PROJECT: 45015.004, George Davis Creek Fish Passage and Stream Restoration Project

REGARDING: Fish Barrier Removal Board Technical Review Team (TRT) Review – Comment Responses

Figure 12 from Hydraulic Report - Recommended surface mix grain size distribution compared to Bathurst (1987) and surface grain size distribution measured in reference reach.

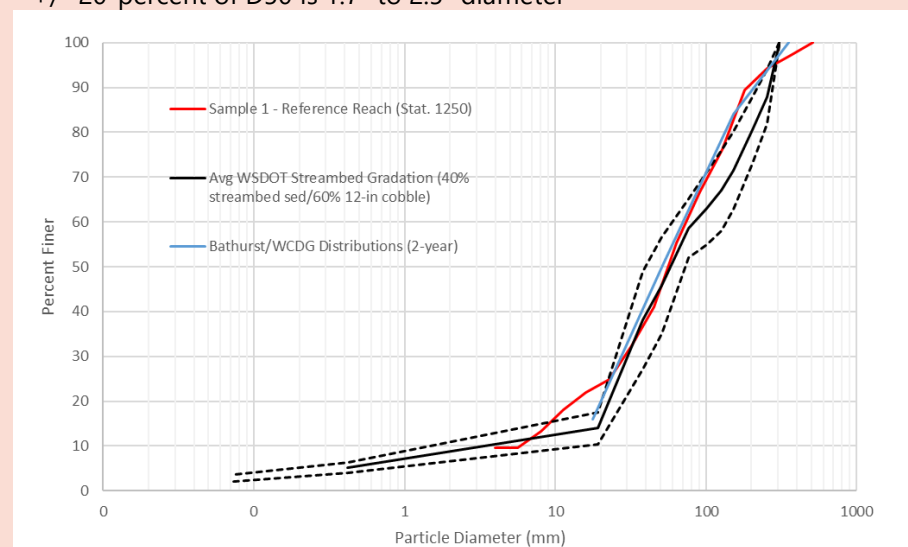
15. The Hydraulic report identifies the pebble count from reference reach as a "well-graded mixture" with a D50 of 54 mm or 2.1 inches. WAC 220-660-190 (6)(a)(vi) states "The median particle size of sediment placed inside the stream-simulation culvert must be approximately twenty percent of the median particle size found in a reference reach of the same stream." The proposed sediment mix 1 "three parts 12 inch" cobbles mixed with two parts streambed sediments". Please provide the gradation curve identifying the D16, D50, D84, D100 confirming the proposed mix meets twenty percent of the median particle size found in the reference reach.

**Response:** This coarse subgrade mix is proposed along the entirety of the lower project reach, not just the culvert crossings, to prevent excessive incision. Finer WSDOT-specified

streambed material will be washed into the coarse subgrade layer to seal the bed and prevent subsurface flow.

Gradation curve and characteristic grain sizes of the mix are provided below:

Characteristic Grain Diameter	Reference Reach	Proposed Surface Mix #1
D100	20" (512 mm)	12" (305 mm)
D90	7.1" (180 mm)	10" (254 mm)
D84	6.8" (165 mm)	9" (225 mm)
D50*	2.1" (54 mm)	2.3" (58 mm)
D16	0.4" (11 mm)	0.7" (18 mm)

\* +/- 20-percent of D50 is 1.7" to 2.5" diameter

Alternatives to the continuous subgrade mix can be considered; for example, use of buried grade control, in development of the 90% design.
